T-14738

REFERENCE: District Temporary Transfer Application T-14738

In the Matter of Transfer Application T-14738, Lake County	))))	FINAL ORDER APPROVING TEMPORARY CHANGES IN PLACES OF USE, POINTS OF APPROPRIATION, AND ADDITIONAL POINTS OF APPROPRIATION

T-14738 - From Wells

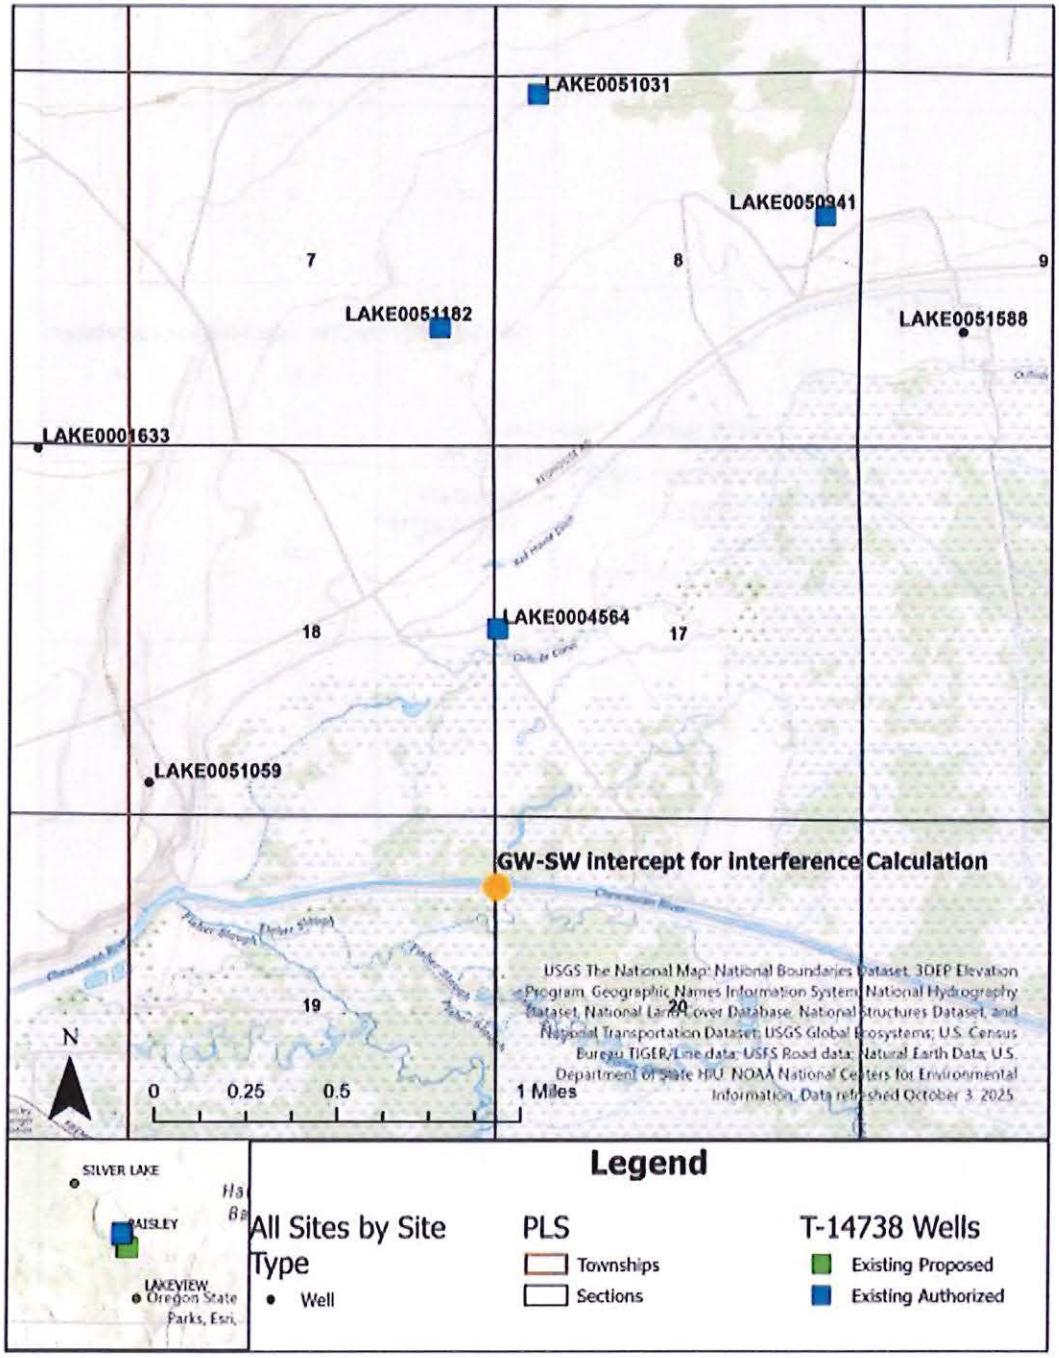
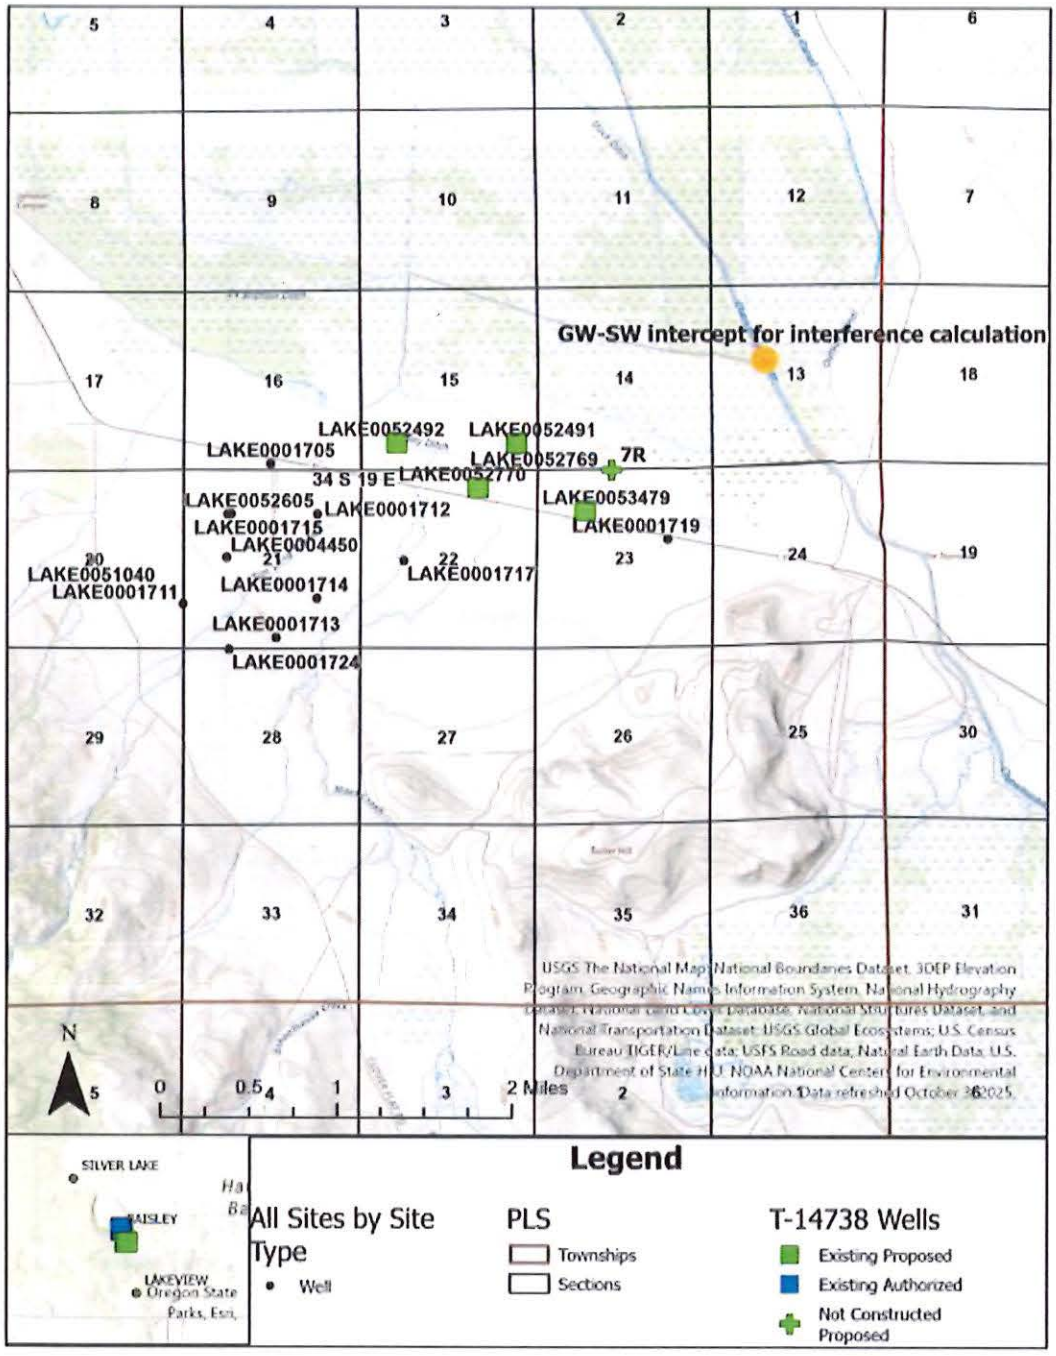
☒ Yes ☐ No Comments: The proposed change will move groundwater pumping about 6.8 to 8.8 mile south from the north side of Upper Chewaucan Marsh to the south side of Upper Chewaucan Marsh (see attached maps). The proposed change will move groundwater pumping closer to a different set of groundwater right wells (see attached maps).

☒ Yes ☐ No Comments: Yes. Despite the proposed POA change moving the net groundwater pumping further away from Chewaucan River, which typically decreases the net seasonal groundwater level drawdown at the river and the net groundwater interference with the river, the proposed POA change will likely increase the net seasonal groundwater level drawdown at the river and the net groundwater interference with the river due to a higher percentage of "To" wells sourcing water from the shallow basin fill sediments (see the attached seasonal drawdown calculation and seasonal interference calculation summary).

The proposed POA change will likely increase the net seasonal groundwater level drawdown at the river and the net groundwater interference with the river given the current "From" POA wells tap groundwater from mostly from the deeper predominantly volcanic rock and sediment unit (73%) and less from the shallower predominantly basin fill sediment unit (27%) (percentages based upon 2002 to 2022 reported water use for certificates 93777 and 93778); whereas the proposed "To" POA wells tap groundwater less from the deeper predominantly volcanic rock and sediment unit (possibly 40%, two wells, driller report indicates well yield from 500 to 1,200 gpm) and more from the shallower predominantly basin fill sediment unit (about 60%, three wells, driller reports indicate well yields from 2,700 to 3,000 gpm each). This is less protective of shallower wells and surface water. Consequently, the seasonal groundwater interference with the river at the end of the irrigation season (240 days) is calculated to increase from about 11.5% of the pumping rate when pumping the "From" wells to about 23.7% of the pumping rate when pumping the "To" wells. This results in an estimated additional 0.21 cfs of surface water depletion after 240 days of pumping at the pro-rated rate.

Condition 7T (modified) for both the proposed "To" wells: "Prior to use, the proposed "To" wells shall be configured to allow a strictly clean water (no oil) static water level measurements with an electric-tape. That can include measurement access via an unobstructed vertical discharge pipe that allows the groundwater level to fluctuate freely within the discharge pipe (no valves, etc.). Otherwise, a dedicated measuring tube must be installed prior to use. The tube must be unobstructed, have a diameter of ¾ inch (0.75 inch) or greater, and pursuant to figure 200-5 in OAR 690-200."

Area Hydrographs

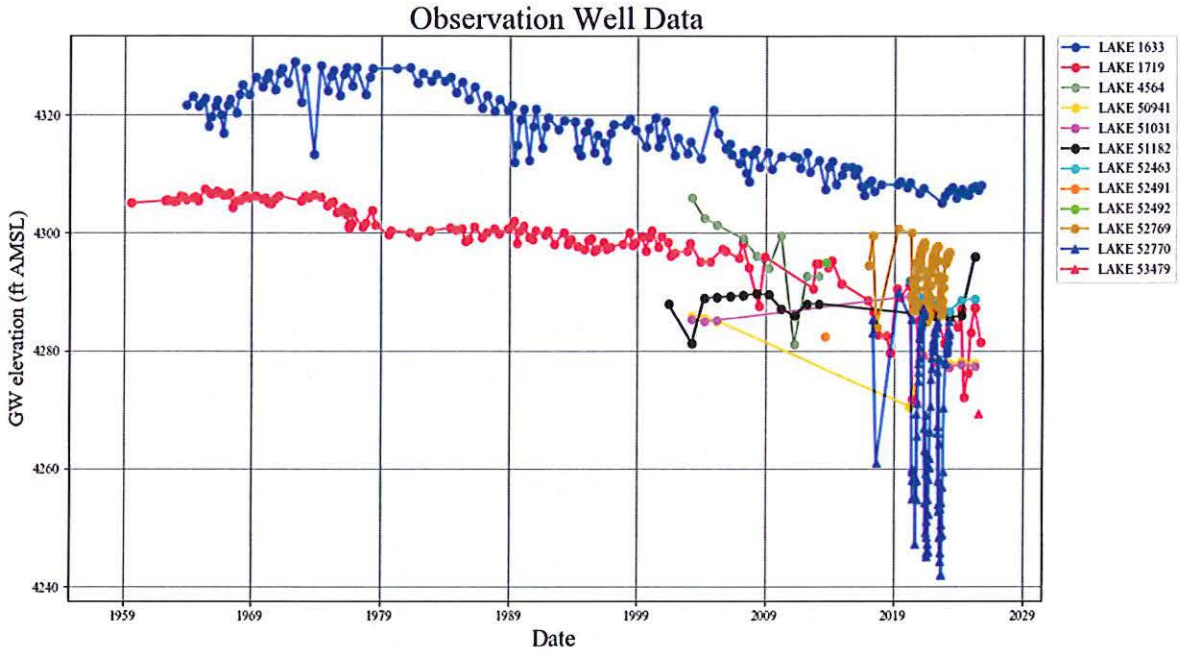
Additionally, the proposed change moves groundwater pumping into a vicinity that appears to be experiencing a groundwater level decline since 2005 (see attached hydrographs). The groundwater level at well LAKE 1719 is relatively stable, near 4302 feet elevation amsl from 1960 to the mid-1970s, a decline of about 5.5 feet from the mid-1970s to early 1980s to a new equilibrium of about 4297 feet elevation amsl that is close to the Chewaucan River stage near the Narrows (relatively steady from about 1980 to 2005), and an ongoing decline since 2005, possibly taking the groundwater level below the river bottom. The groundwater level decline in the 1970s and after 2010 may correspond to increased groundwater development in the area.

T-14738 - From Wells

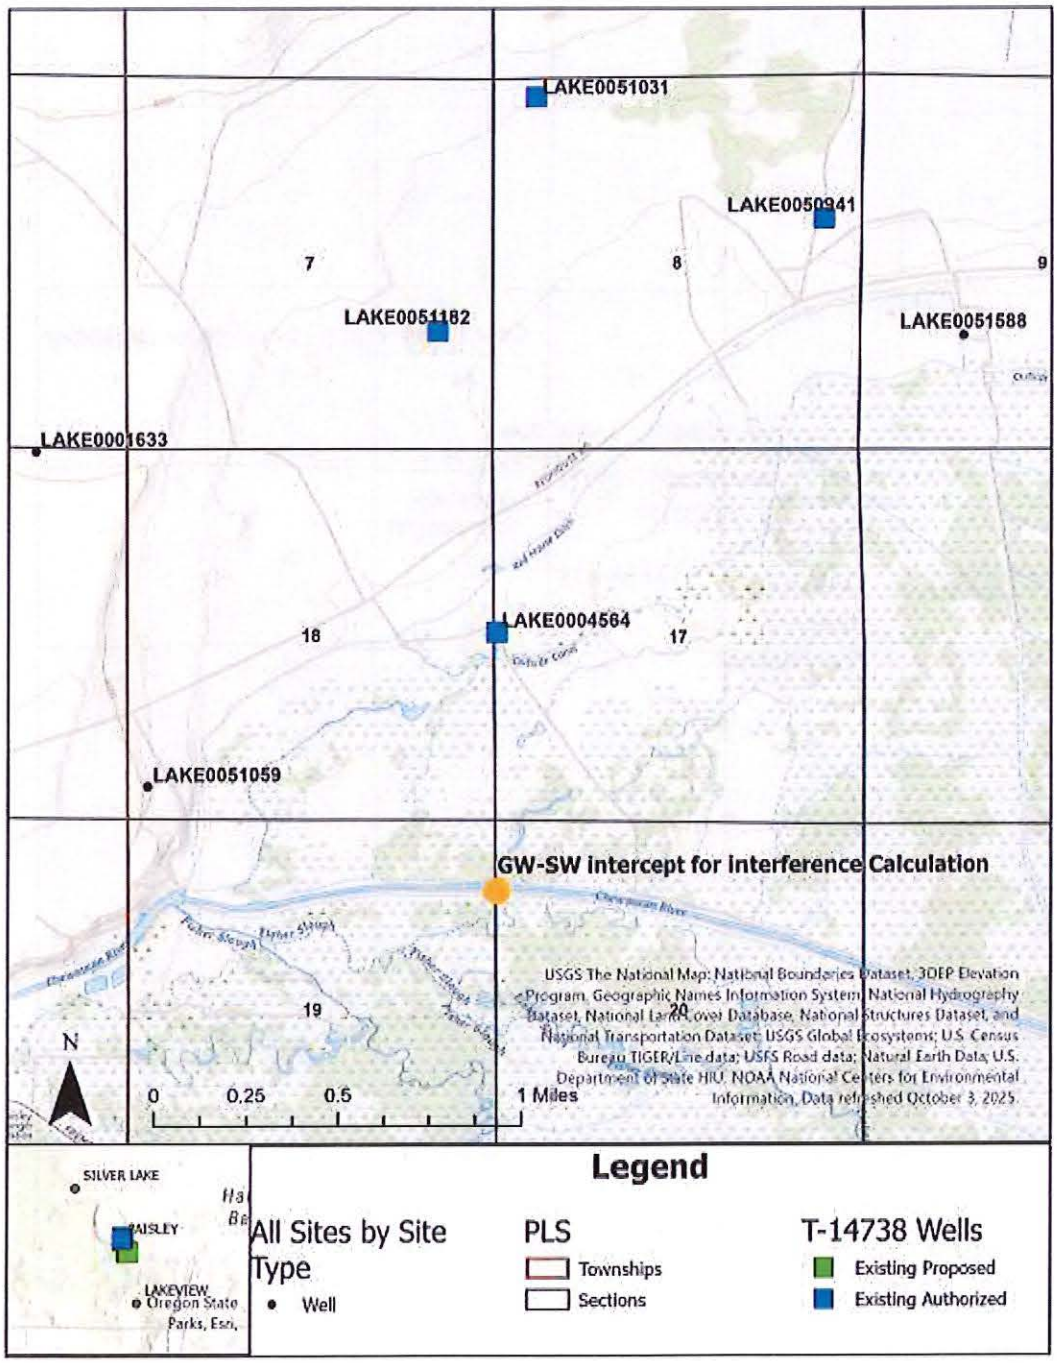
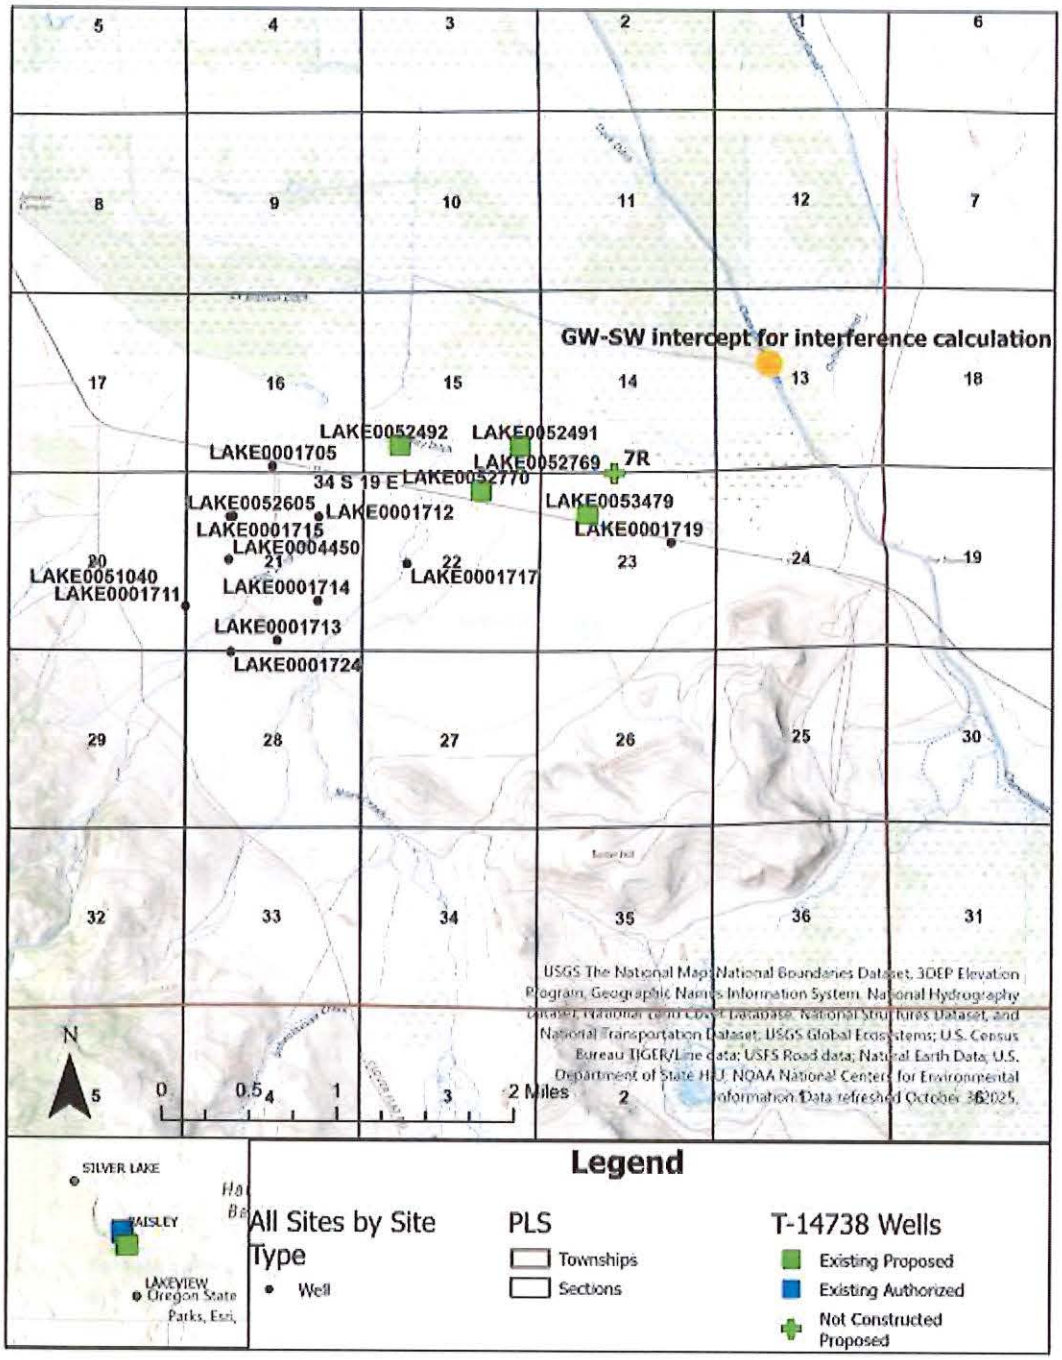
☒ Yes ☐ No Comments: The proposed change will move groundwater pumping about 6.8 to 8.8 mile south from the north side of Upper Chewaucan Marsh to the south side of Upper Chewaucan Marsh (see attached maps). The proposed change will move groundwater pumping closer to a different set of groundwater right wells (see attached maps).

☒ Yes ☐ No Comments: Yes. Despite the proposed POA change moving the net groundwater pumping further away from Chewaucan River, which typically decreases the net seasonal groundwater level drawdown at the river and the net groundwater interference with the river, the proposed POA change will likely increase the net seasonal groundwater level drawdown at the river and the net groundwater interference with the river due to a higher percentage of "To" wells sourcing water from the shallow basin fill sediments (see the attached seasonal drawdown calculation and seasonal interference calculation summary).

The proposed POA change will likely increase the net seasonal groundwater level drawdown at the river and the net groundwater interference with the river given the current "From" POA wells tap groundwater from mostly from the deeper predominantly volcanic rock and sediment unit (73%) and less from the shallower predominantly basin fill sediment unit (27%) (percentages based upon 2002 to 2022 reported water use for certificates 93777 and 93778); whereas the proposed "To" POA wells tap groundwater less from the deeper predominantly volcanic rock and sediment unit (possibly 40%, two wells, driller report indicates well yield from 500 to 1,200 gpm) and more from the shallower predominantly basin fill sediment unit (about 60%, three wells, driller reports indicate well yields from 2,700 to 3,000 gpm each). This is less protective of shallower wells and surface water. Consequently, the seasonal groundwater interference with the river at the end of the irrigation season (240 days) is calculated to increase from about 11.5% of the pumping rate when pumping the "From" wells to about 23.7% of the pumping rate when pumping the "To" wells. This results in an estimated additional 0.21 cfs of surface water depletion after 240 days of pumping at the pro-rated rate.

Condition 7T (modified) for both the proposed "To" wells: "Prior to use, the proposed "To" wells shall be configured to allow a strictly clean water (no oil) static water level measurements with an electric-tape. That can include measurement access via an unobstructed vertical discharge pipe that allows the groundwater level to fluctuate freely within the discharge pipe (no valves, etc.). Otherwise, a dedicated measuring tube must be installed prior to use. The tube must be unobstructed, have a diameter of ¾ inch (0.75 inch) or greater, and pursuant to figure 200-5 in OAR 690-200."

Area Hydrographs

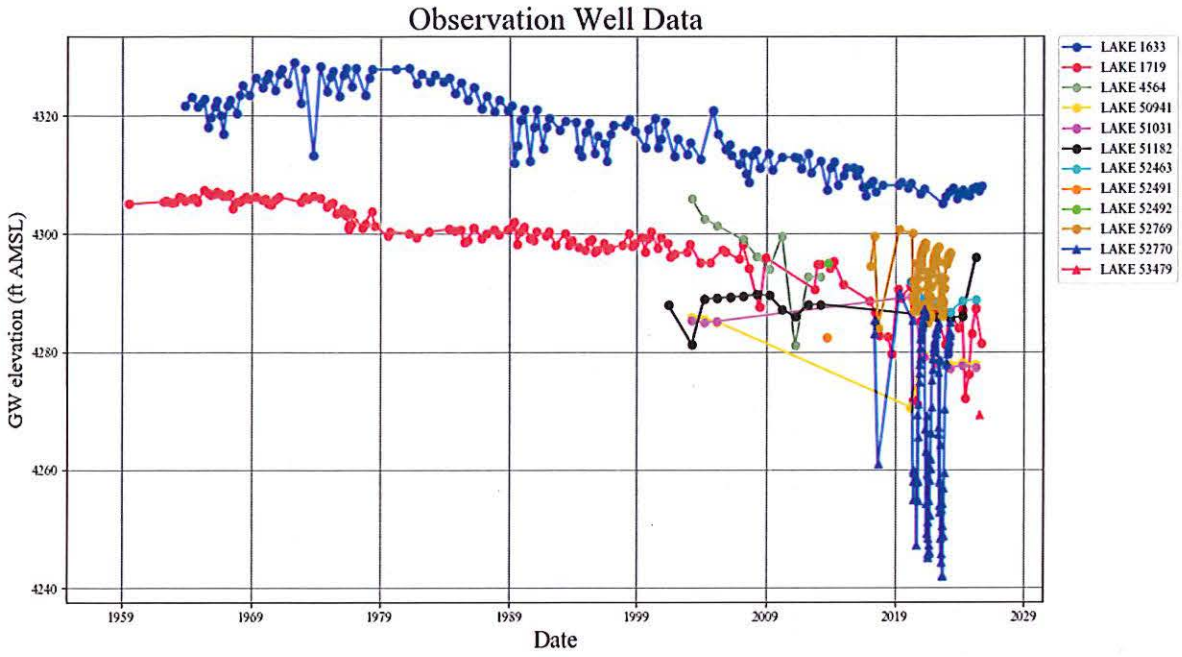
Additionally, the proposed change moves groundwater pumping into a vicinity that appears to be experiencing a groundwater level decline since 2005 (see attached hydrographs). The groundwater level at well LAKE 1719 is relatively stable, near 4302 feet elevation amsl from 1960 to the mid-1970s, a decline of about 5.5 feet from the mid-1970s to early 1980s to a new equilibrium of about 4297 feet elevation amsl that is close to the Chewaucan River stage near the Narrows (relatively steady from about 1980 to 2005), and an ongoing decline since 2005, possibly taking the groundwater level below the river bottom. The groundwater level decline in the 1970s and after 2010 may correspond to increased groundwater development in the area.
